Well Name: RIO BLANCO 4-33 FED COM	Well Location: T23S / R34E / SEC 4 / SWNE / 32.334358 / -103.471479	County or Parish/State: LEA / NM
Well Number: 104H	Type of Well: OIL WELL	Allottee or Tribe Name:
Lease Number: NMNM19142	Unit or CA Name: RIO BLANCO 4-33 FED COM 39H	Unit or CA Number: NMNM140035
US Well Number: 3002554248	Operator: DEVON ENERGY PRODUCTION COMPANY LP

Sundry ID: 2840941

Type of Action: APD Change

Procedure Description: Engineering Only - Devon Energy Production Company L.P. respectfully requests the following changes to the approved APD: Per L.Vo verbal approval, request addition of pilot hole: 8-3/4" Pilot Hole and Plugging Program 1) 8-3/4" Pilot hole from 11850-14650 2) Pilot hole will be plugged back per NMOCD P&A requirements with a cement plug 3) All cement will be 100ft in length +10% per 1000ft of TVD 4) Plug depths will be verified and tagged in the plug back (min 6hr wait time) 5) Devon will contact the NMOCD and give notice before performing any of the aforementioned procedures including the tagging of cement 6) Whip stock will be set around 9,000ft Please see attached revised drill plans and supporting documentation.

10M BOPE & Closed Loop Equipment Schematic

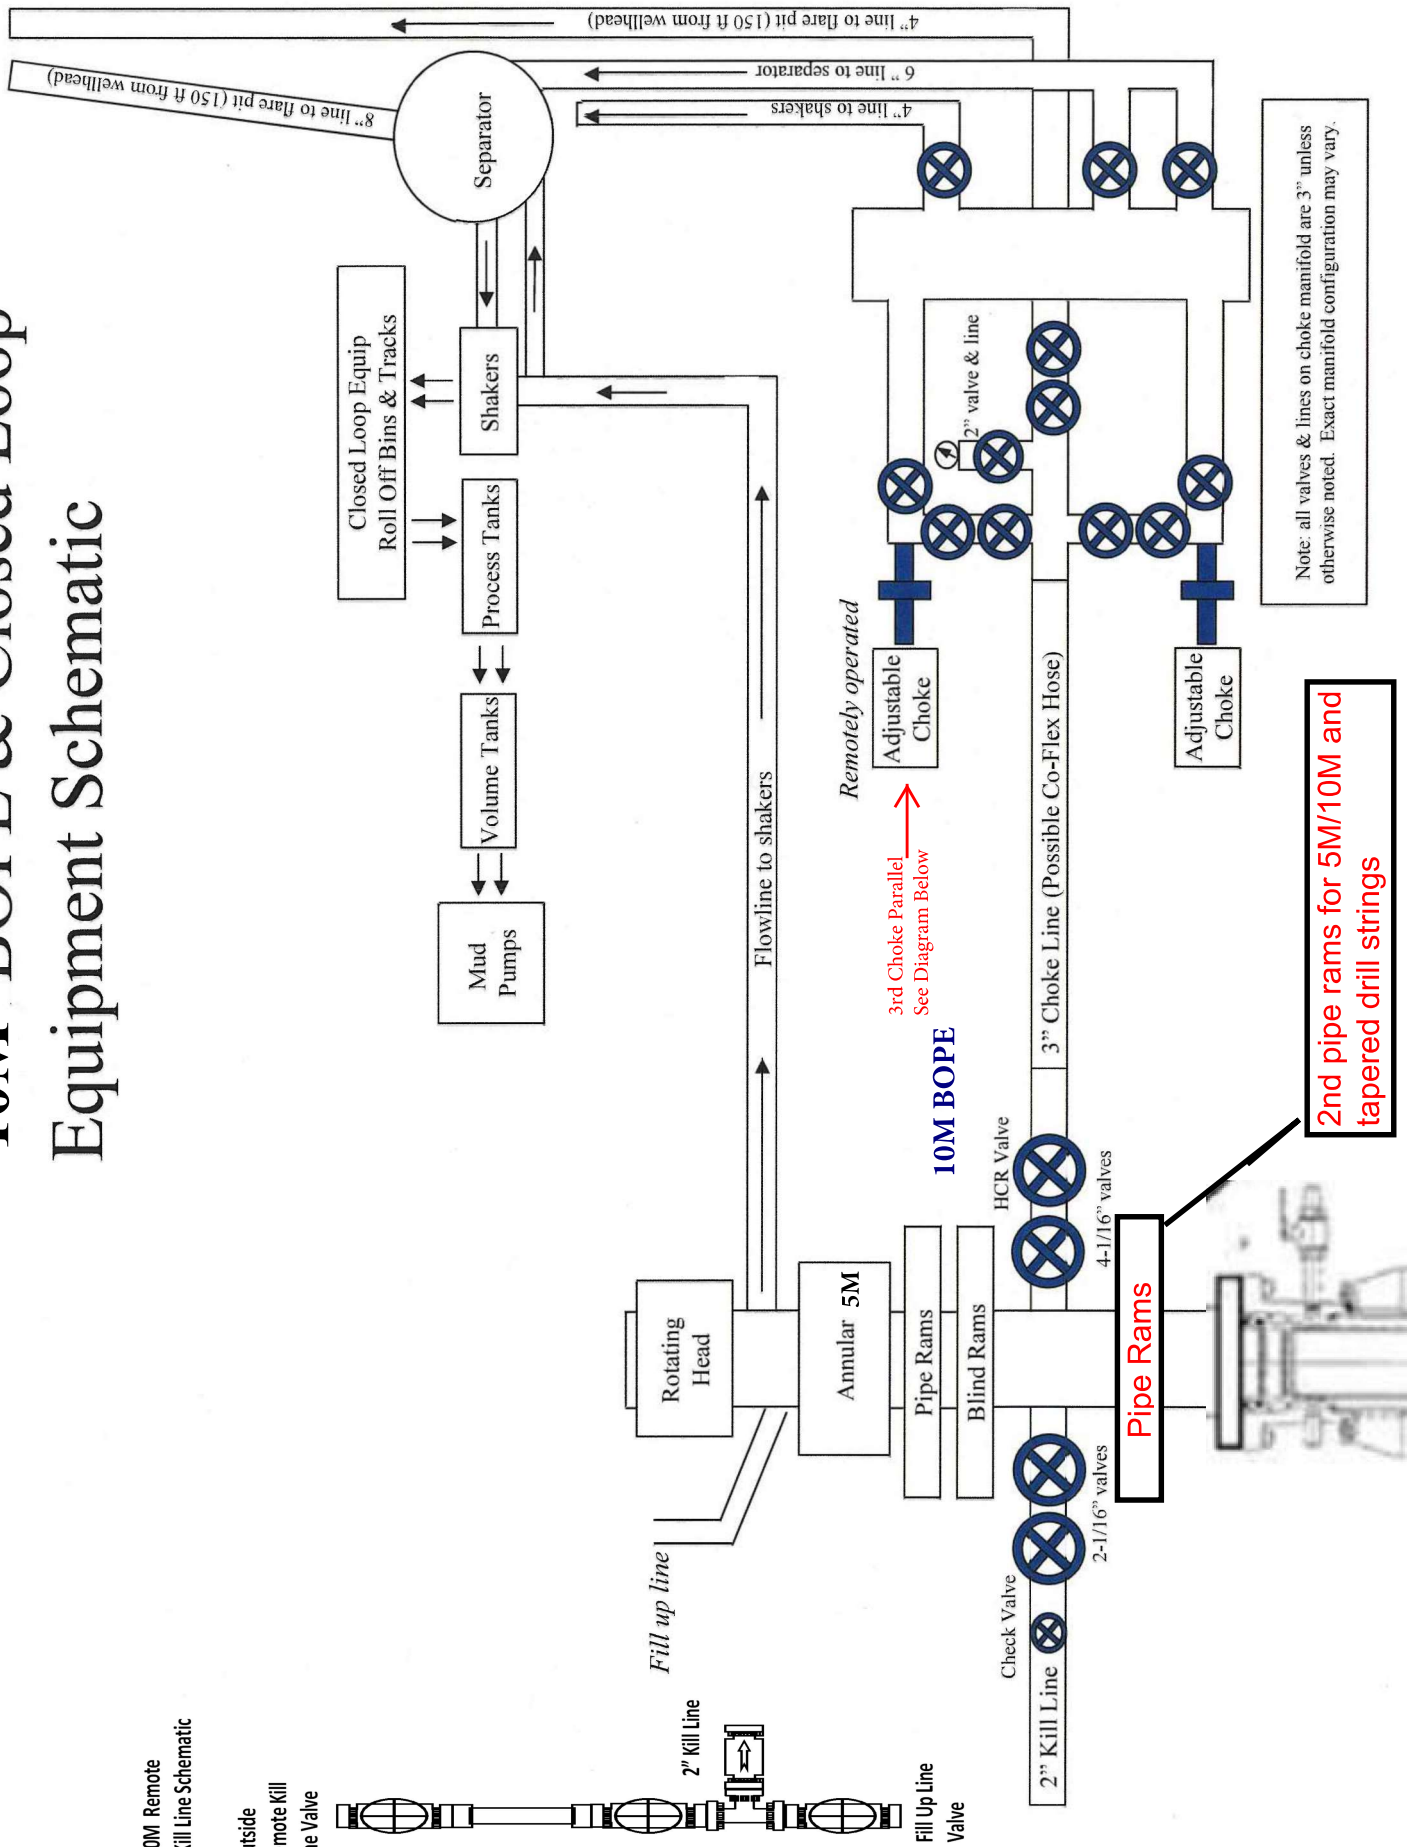
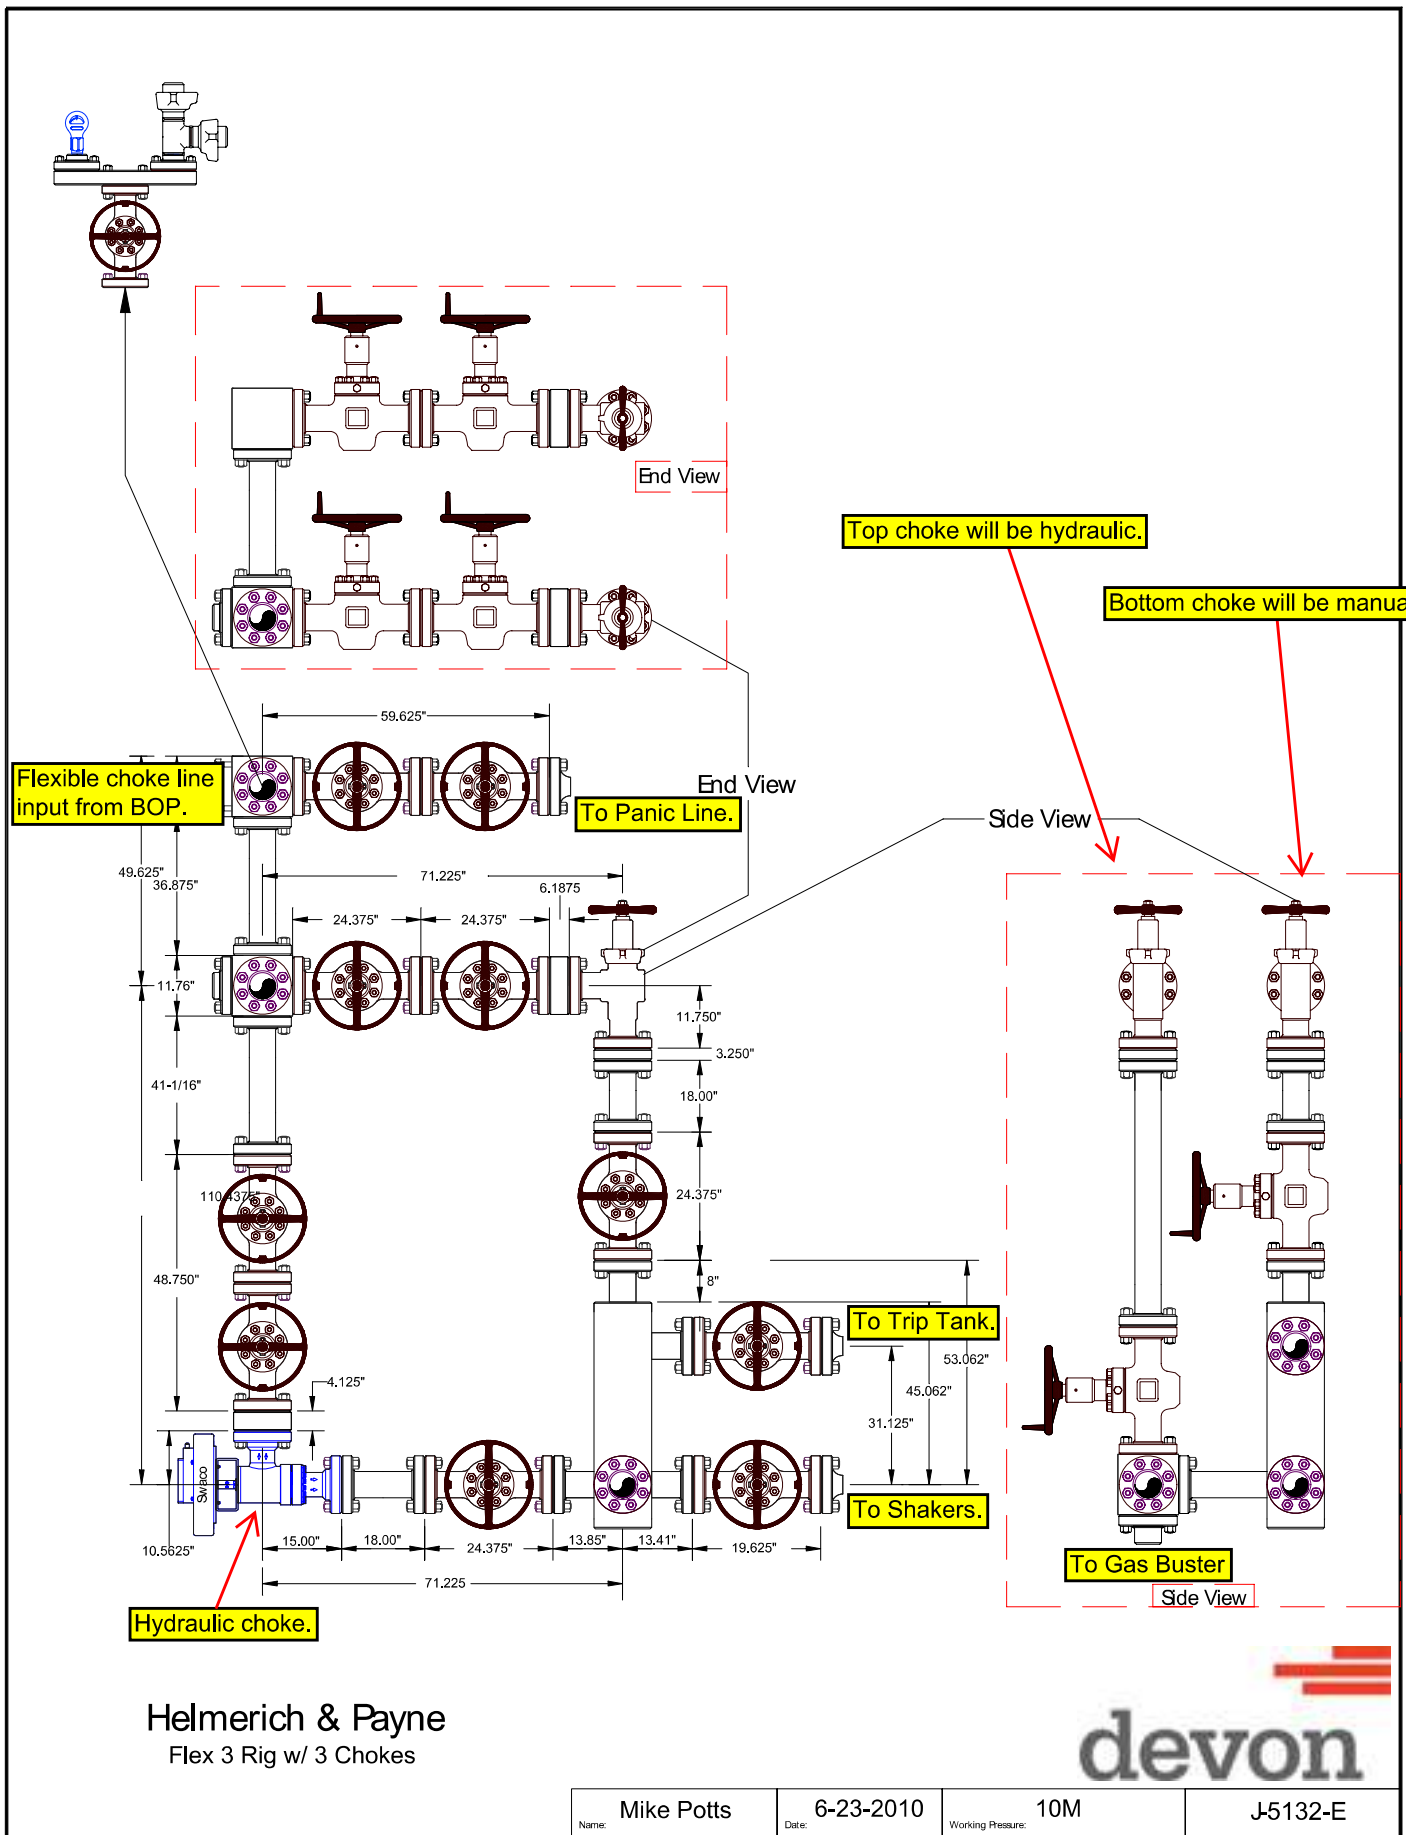
What is the pilot hole size? Please also include the 10M BOPE diagram within the sundry with a well control plan.

A full BOPE test is required when drilling below the intermediate casing, no break testing allow.

Here is the updated drill plan, 10M BOPE schematic and well control plan.

We will include the # of sacks and BOP schematic in the Sundry document. We will not break test when enter the Wolfcamp and deeper. The pilot hole is 8-3/4" hole.
